Patch Release Note

Patch SB251-13 For SwitchBlade 4000 Series Switches and AT-9800 Series Switches

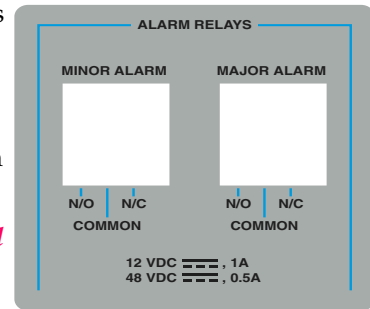
PCR: 03209 MODULE: ALARM**Level: 1**

The action of the MAJOR and MINOR relays does not presently match the illustration located alongside their connections.

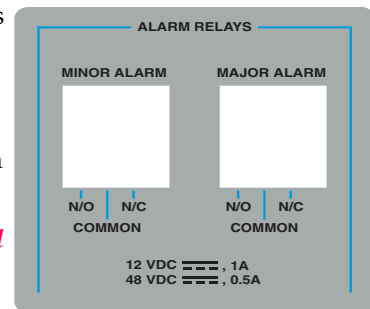
PCR: 03209 MODULE: ALARM Level: 1

The action of the MAJOR and MINOR relays does not presently match the illustration located alongside their connections.
